Platform A1 - Booth area  
Previous comments are  
still valid, see following  
slides

Important: the 12 columns of the Spray Booth have been modified after change of the Scrubber technology by Renault-VAZ

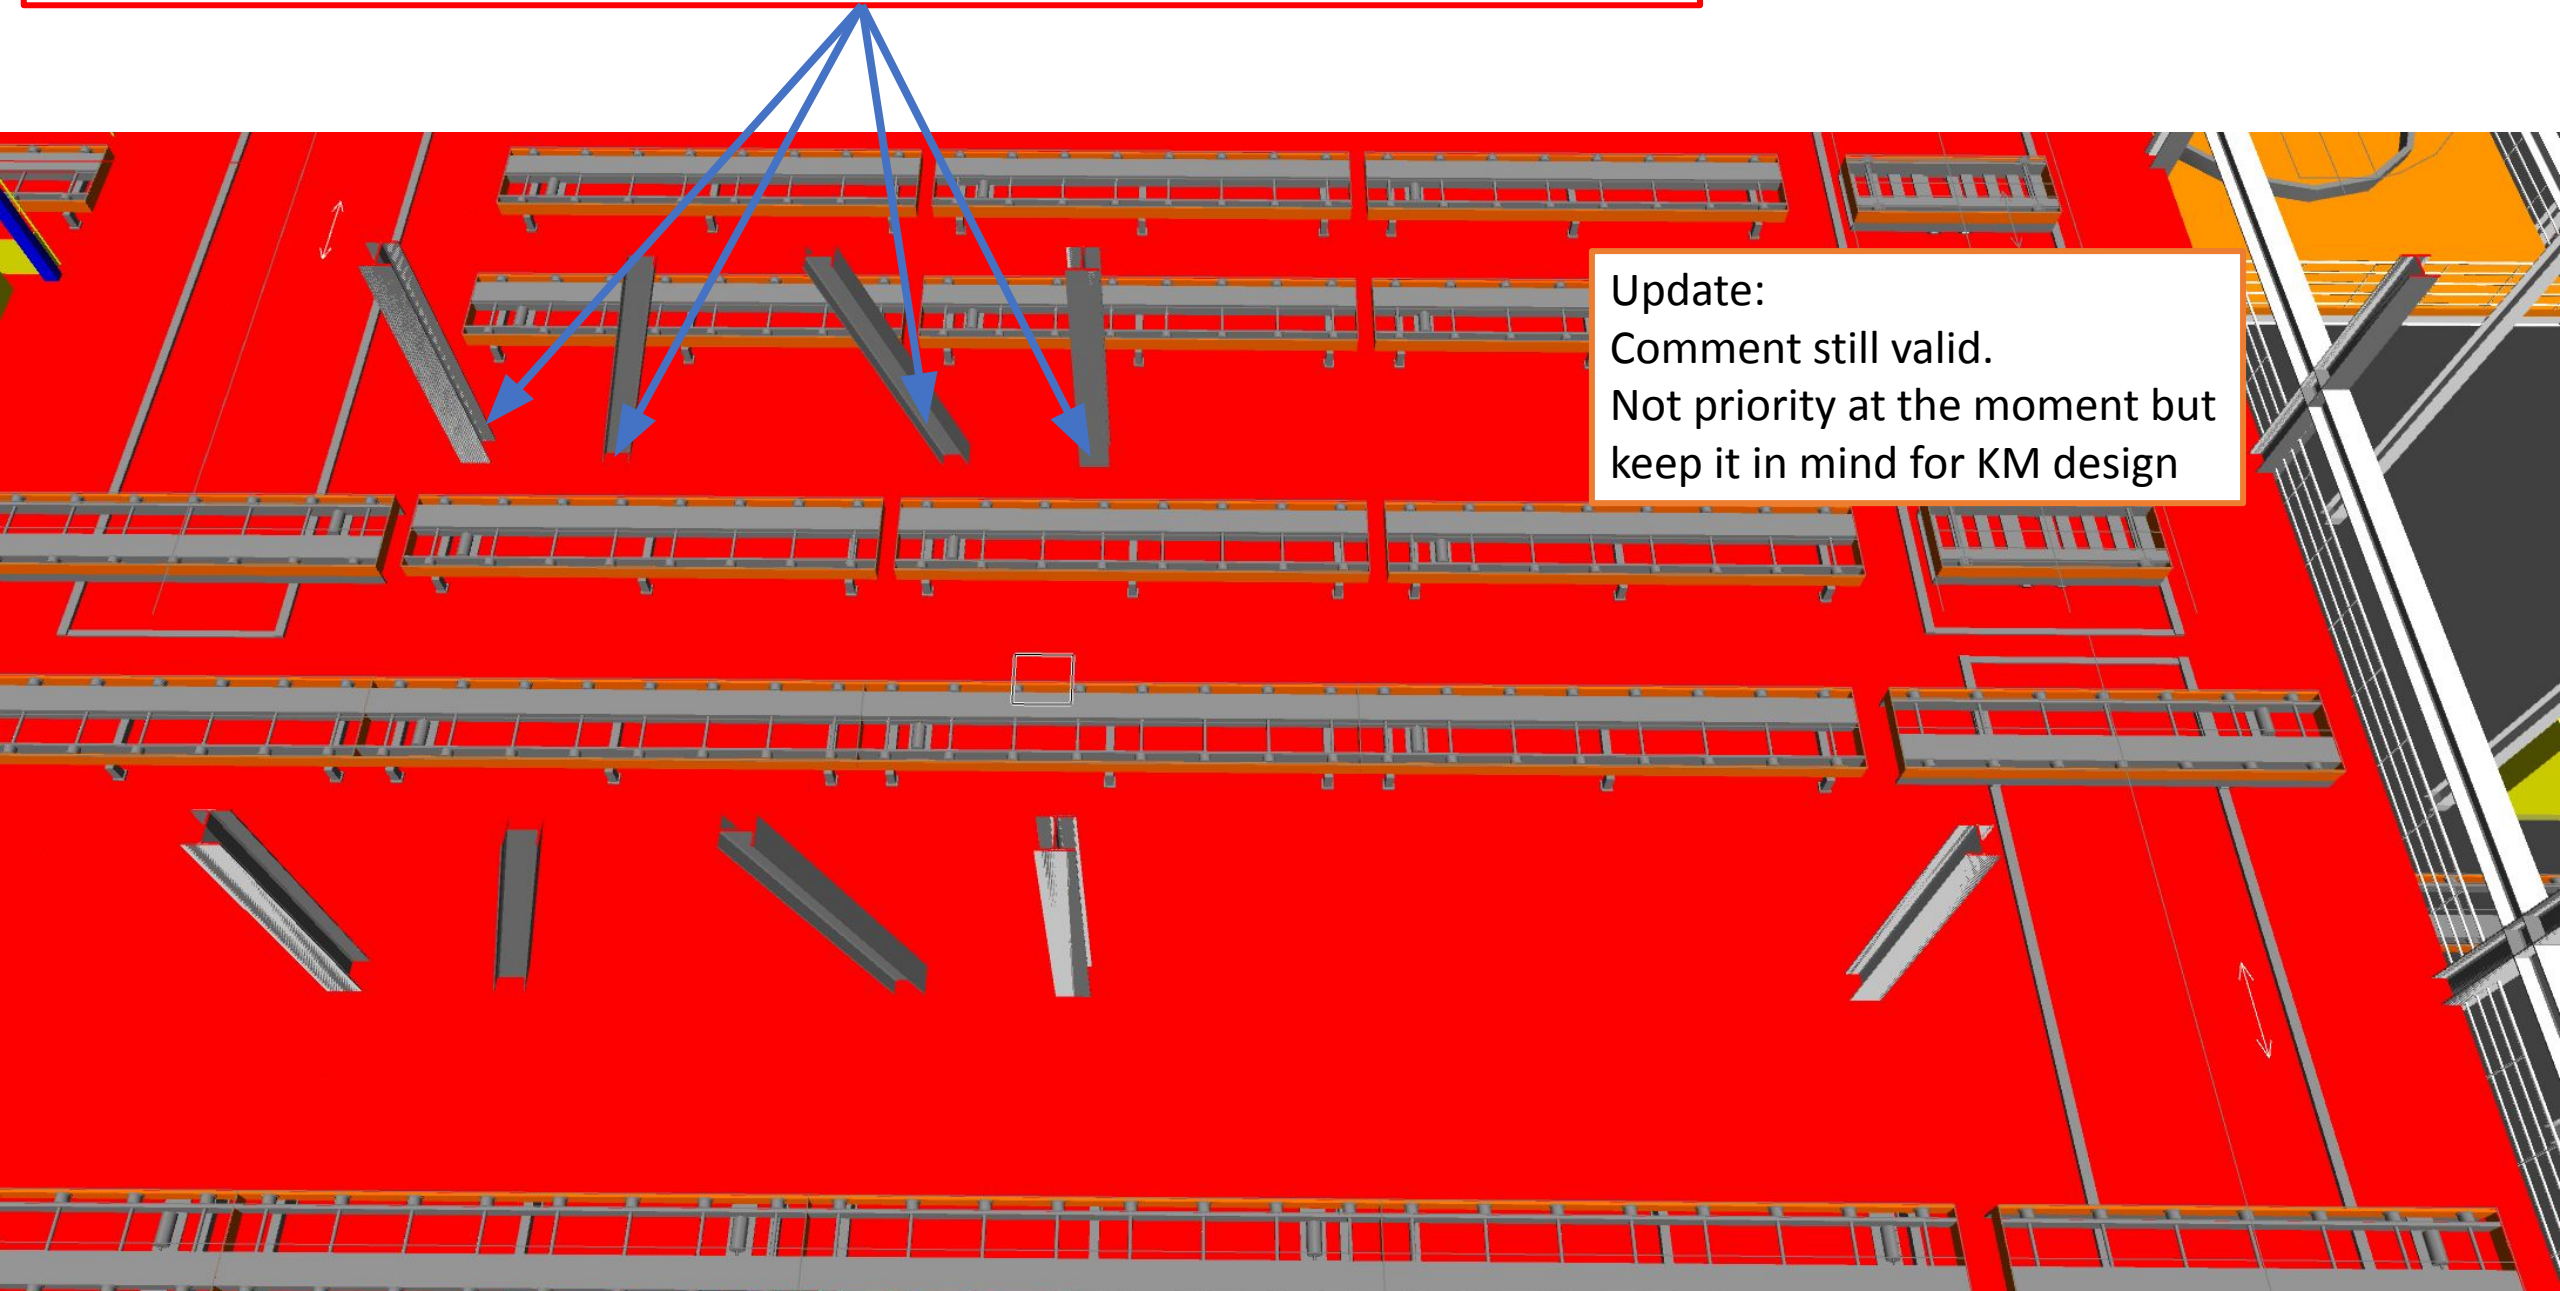
Platform A2: remember to provide holes with kick-plates around existing columns and bracing (typical) Axes 11-12/014-018

Update:  
Comment still valid.  
Not priority at the moment but  
keep it in mind for KM design

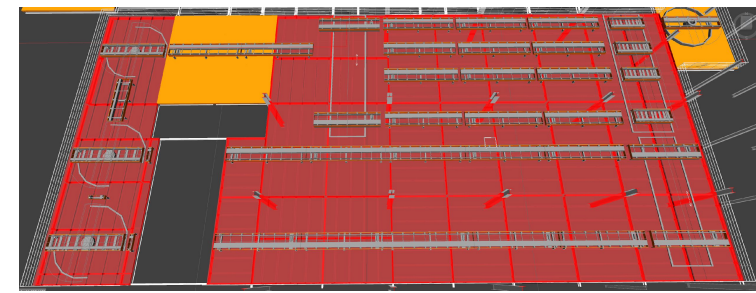
Platform A2: finally we need to discuss about longitudinal support for Conveyor Roller-beds, turning tables and transfer-tables  
I will send this information after I have discussed with my colleague from Conveyor dpt  
Axes 10-12/014-020

As I told you last time I need to give you precise info of where to support the conveyor tables (roller-beds, transfer table, turning table)  
In the meantime consider the ones in these pictures (for conveyor center-lines use the Gen. Layout)
